TECHNICAL BULLETIN INDEX
Sorted by Bulletin Number
04/03/86

TANDY COMPUTER PRODUCTS

DATE: December 8, 1983
REVISION DATE: April 18, 1988
BULLETIN NO: 2000:1
PRODUCT: 26-5140 High Resolution Graphics PCB
SUBASSEMBLY: AX-9450 Graphics PCB
SUBASSEMBLY REVISION: Rev. PP2

Figure 1

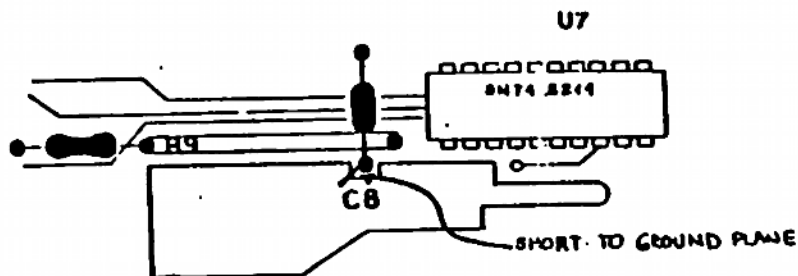
DISCUSSION/PROCEDURE: Some early production hard drive controller boards were missing a resistor (R28), had two wrong valued capacitors installed (C5 and C6), and had one capacitor which was not grounded properly (C8). All Tandy 2000 hard drive controller boards should be checked for the following:

1. Make sure R28 has a 470 ohm 1/4 watt 5% resistor installed in that silk screen position.
2. Check C5 and C6 to insure 100 pfd capacitors are installed and not 150 pfd capacitors.
3. Check C8 to insure that the open pin is attached to the ground plane nearest it (Refer to Figure 1).

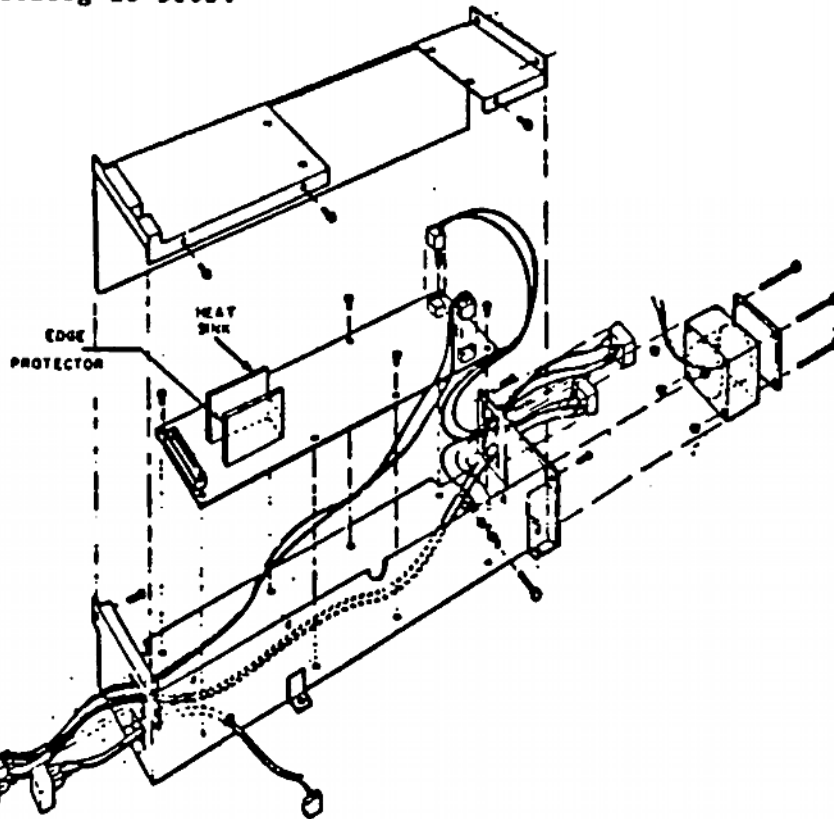
Remove the plastic snap retaining plug on either side of the Controller board and replace with sheet metal screws. The screws will give the required grounding for the board.

Figure 1.

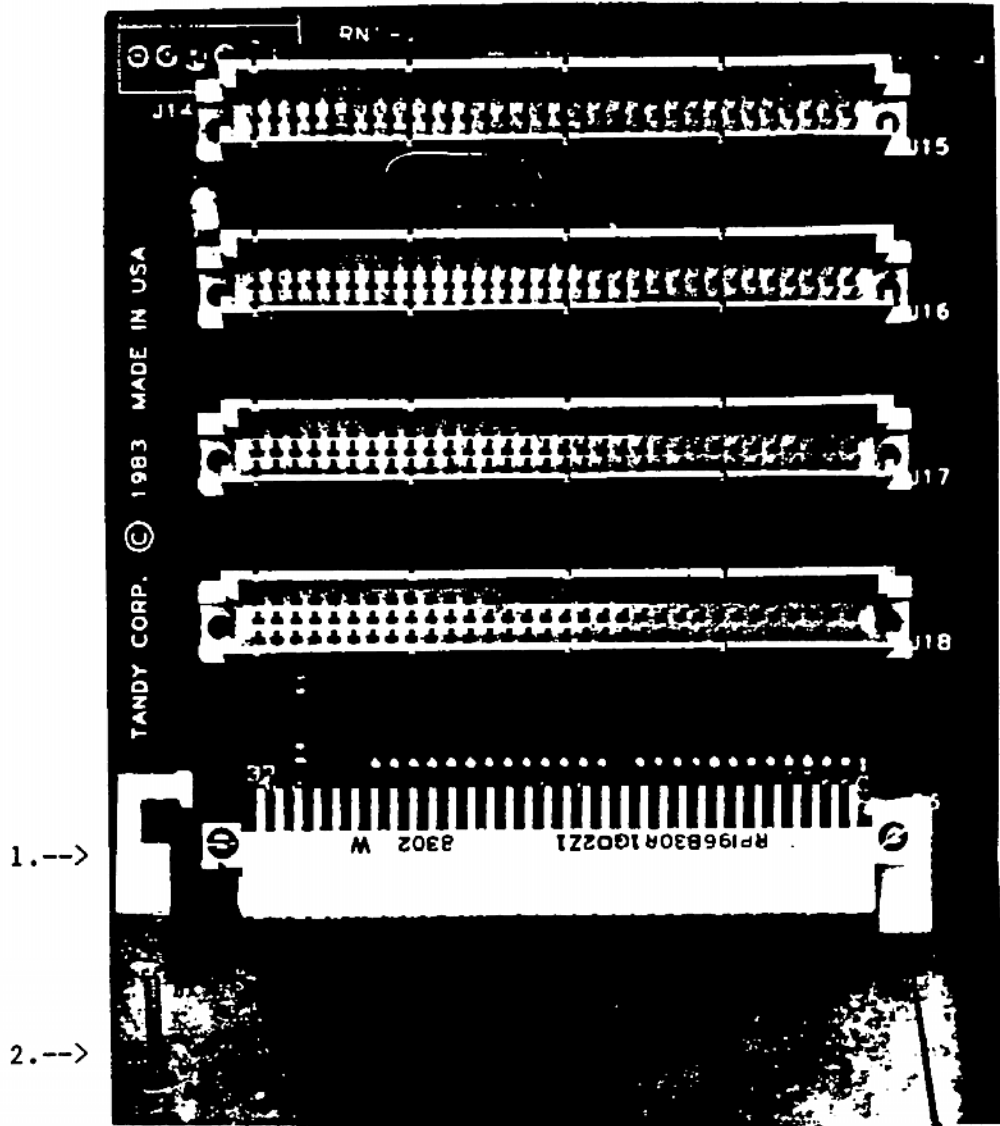
3. (Refer to figure 1.) Remove screws and nuts holding (P6)(96-pin connector) to the motherboard. Replace the original screws with the #4 x 1/4" screws and the #6 lock washers. These are used to hold the retainer clips tightly in place.

4. (Refer to figure 1.) Place the retainer clips over the screw ears of the connector (P6) behind #6 lock washer if used.
5. Reattach the main logic board to the pan. Reinstall the mother board and insert the two screws into standoff's from bottom side. Thread the two screws into the retainer clips, pulling the two boards together for a tight fit. WARNING: Do not over tighten the screws or you will strip out the retainers.
6. Reassemble unit and test for proper operation.

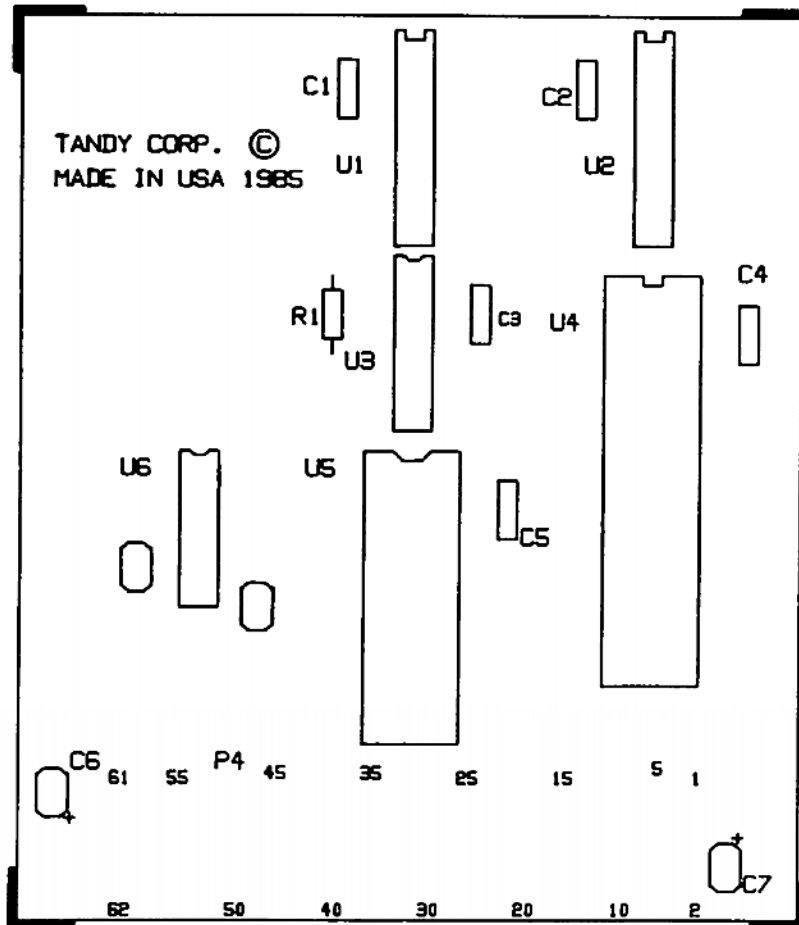
9. Carefully disconnect the connections to the main logic PCB and remove the PCB and metal chassis.
10. There are two case standoffs underneath the main logic PCB. To allow room for the coprocessor PCB the standoff located near the motherboard must be trimmed down, using a large pair of wire cutters or tin snips, as close to the screw as possible.

```
*****  
*                                                                 *  
*           DO NOT FORCE THE BOARD.                               *  
*                                                                 *  
*   If any force is required to seat the boards                 *  
*   the standoff has not been cut short enough.                 *  
*   Note, a shorter screw may be required to                    *  
*   avoid shorting the coprocessor PCB.                          *  
*****
```

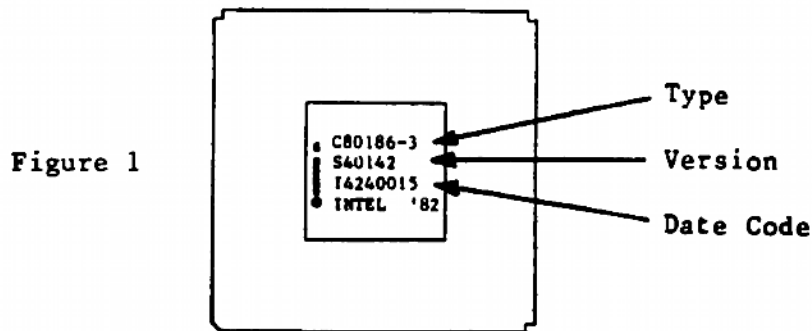
There are two items to check, clock speed and version number. If either one, or both of these numbers are incorrect the chip must be replaced. Figure 1 shows a typical 80186 CPU chip.

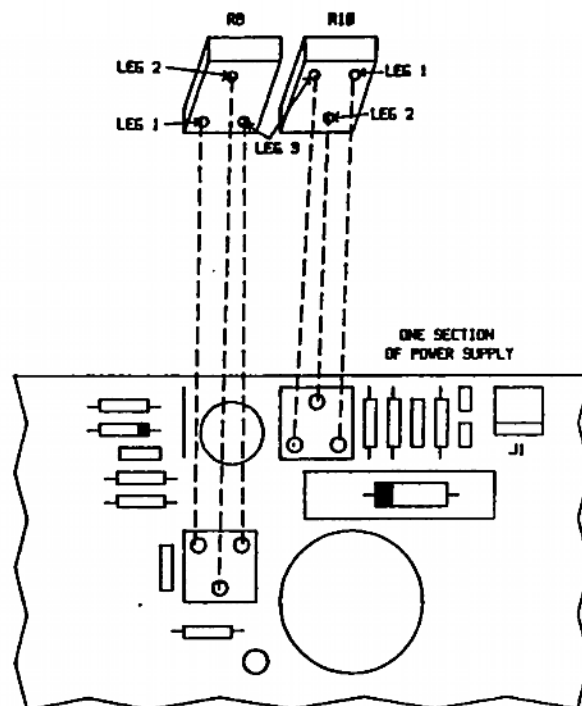
3. Turn the unit off and remove the power supply PCB.
4. Referring to the figure below remove R10 (+5 volt), observing the leg orientation. With an OHM meter measure the resistance between Leg 1 and Leg 2. This is the first fixed resistor value. Measure the resistance between Leg 3 and Leg 2. This is the second fixed resistor value.

6. Remove R8 (+12 volt), observing the leg orientation. The power supply PCB has Leg 3 connected to Leg 2. For this reason only one fixed resistor is required. The value for this fixed resistor can be measured between Leg 1 and Leg 2.

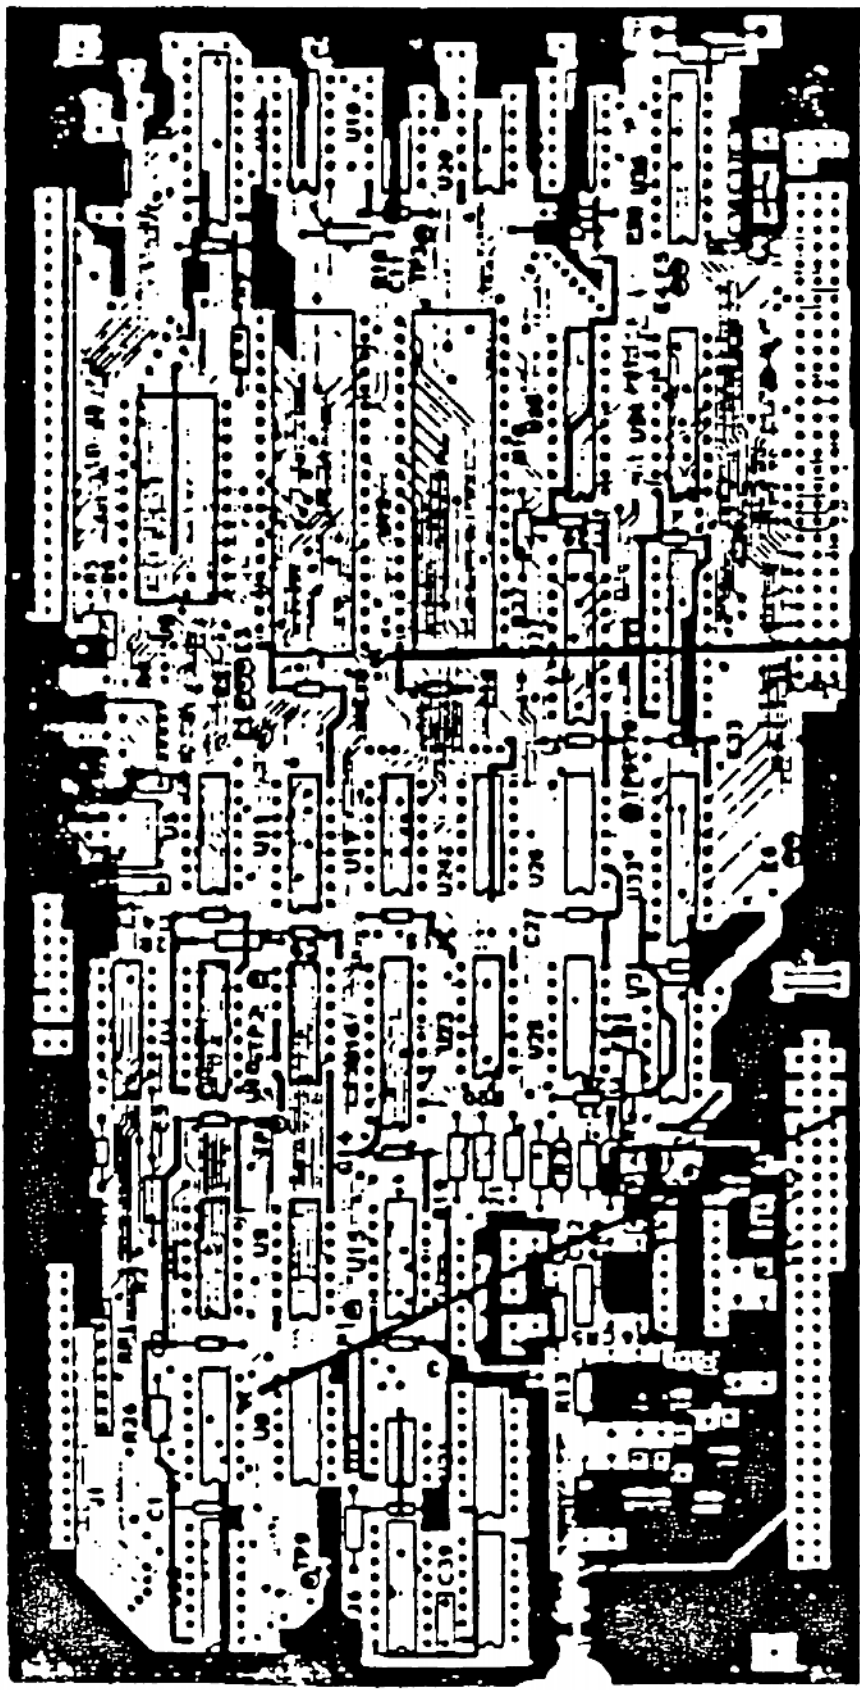
ON THE COMPONENT SIDE REFER TO FIGURE 1:

1. Cut the trace going to U12 pin 1 at the feedthrough.
2. Cut the trace going to U1 pin 6 at pin 6.

Figure 2

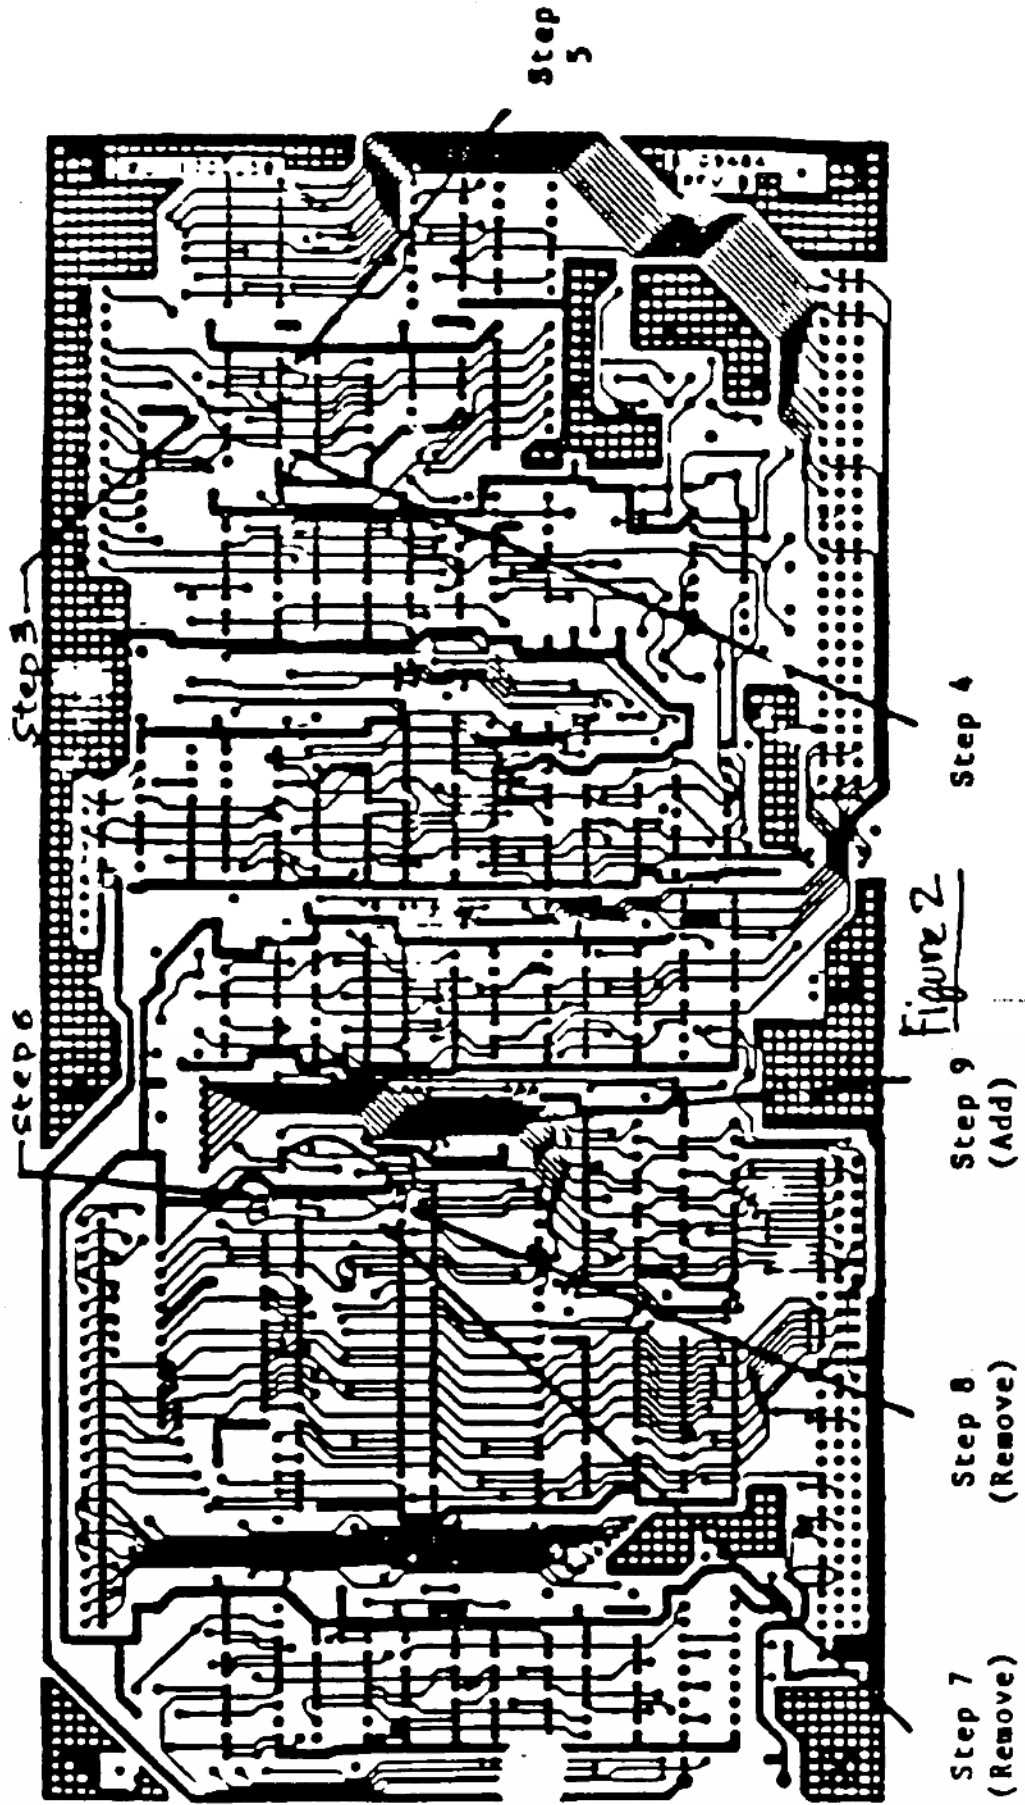
3. Cut the trace going to U1 pin 11 at pin 11.
4. Jumper U1 pin 6 to the feedthrough that used to go between U1 pin 11 and J1 pin 26.
5. Jumper U1 pin 11 to the feedthrough between pins 1 and 2 of U1.
6. Cut the trace from U12 pin 2 at the feedthrough.
7. Jumper U12 pin 1 to the feedthrough just cut away from U12 pin 2.
8. Jumper U12 pin 2 to the feedthrough connected to E2.

ON THE SOLDER SIDE REFER TO FIGURE 2:

1. Remove the jumper from U12 pin 1 to the feedthrough. Refer to Step 7 of the original procedure and drawing.
2. Remove the jumper from U12 pin 2 to the feedthrough. Refer to Step 8 of the original procedure and drawing.
3. Jumper U12 pin 1 to the E2 staking pin. This remakes the trace cut in Step 1 of the original procedure. Refer to Step 9 of the drawing.
4. Refer to the enhanced modification on Page 1 of 6 and perform steps 5, 6, and 8.

Step 1 Figure 3

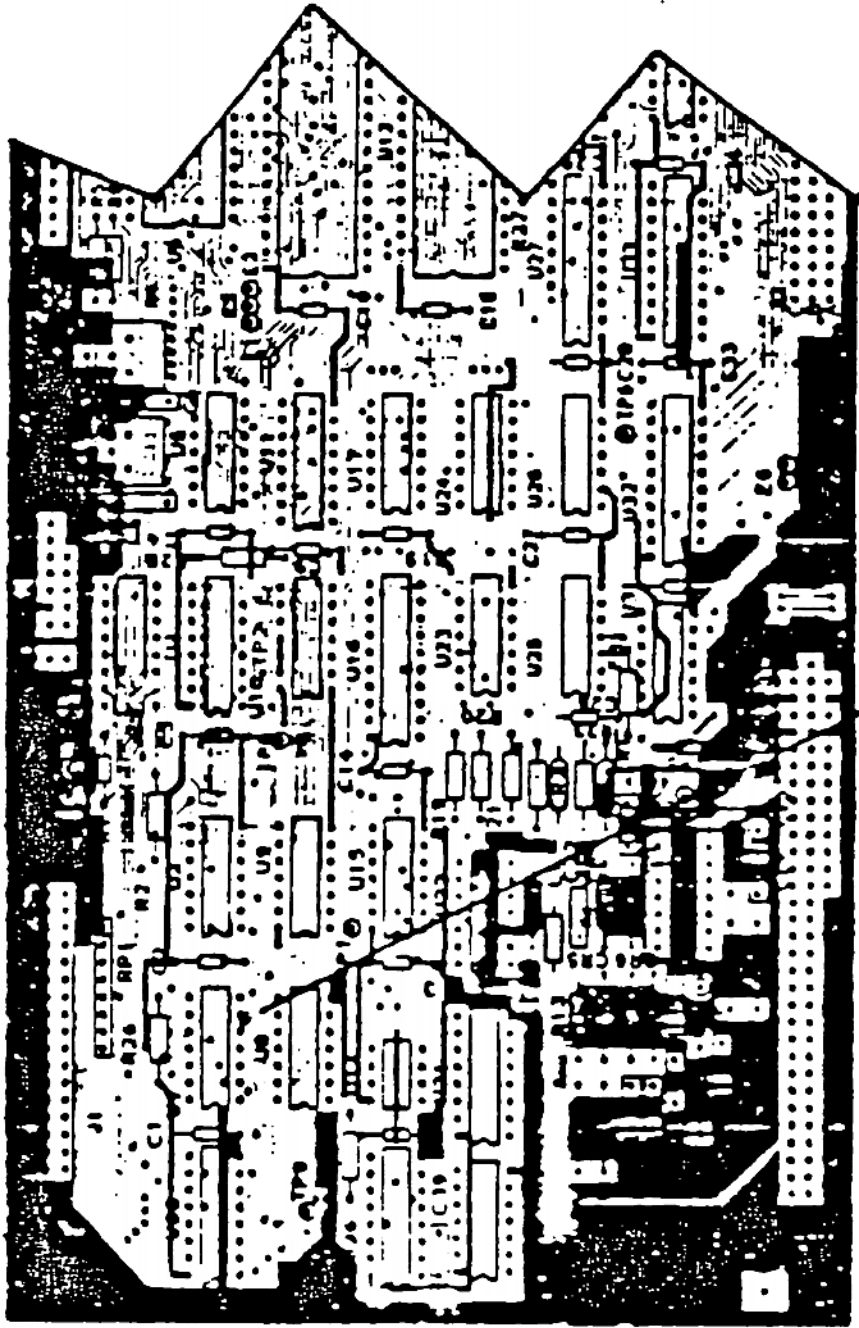
ON THE COMPONENT SIDE REFER TO FIGURE 3:

Figure 4

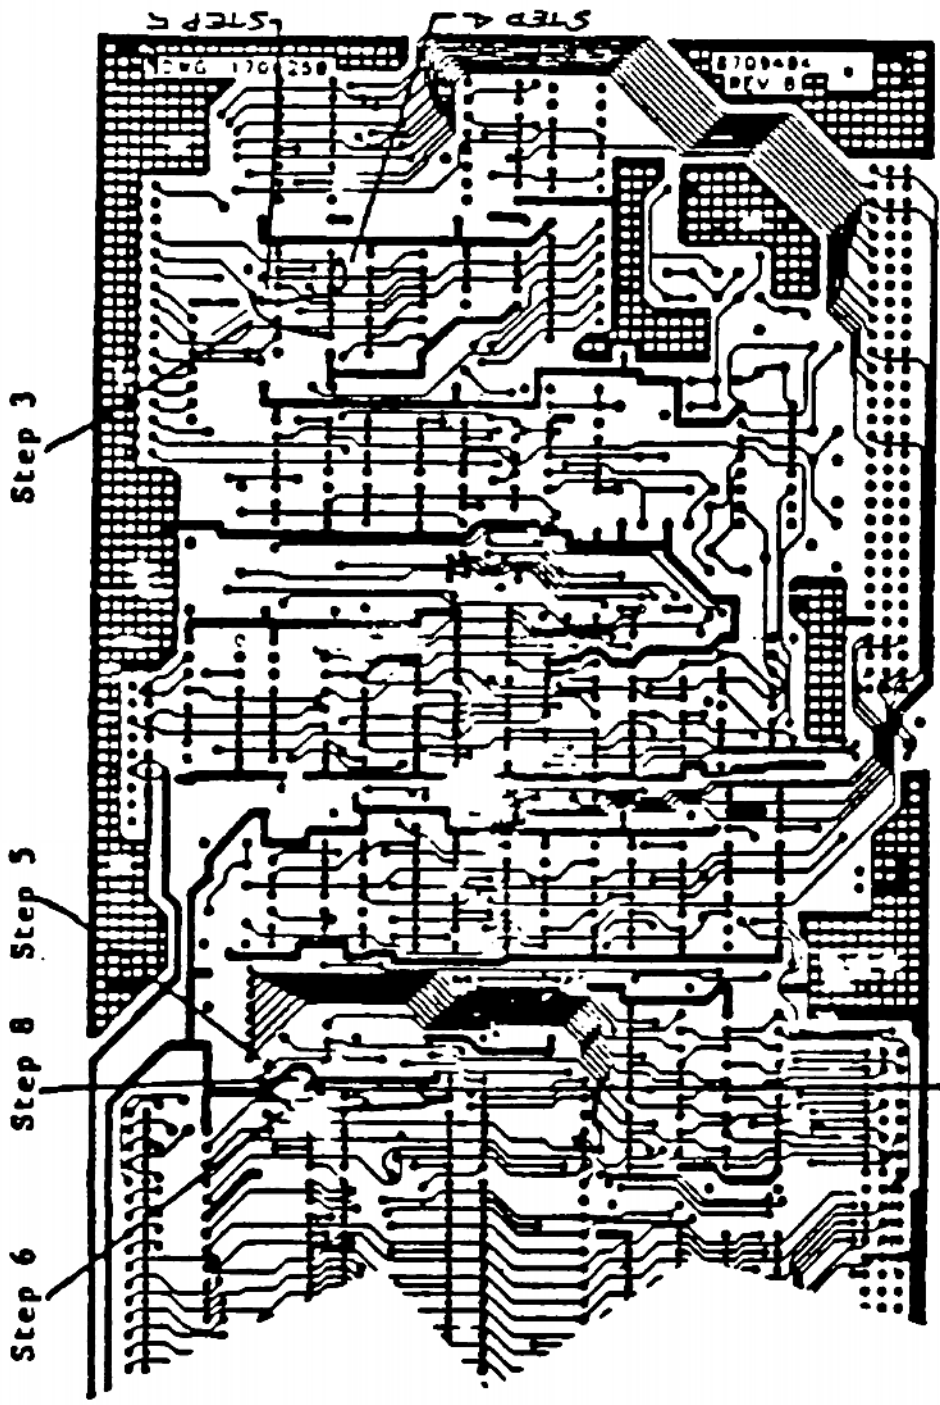
ON THE SOLDER SIDE REFER TO FIGURE 4:
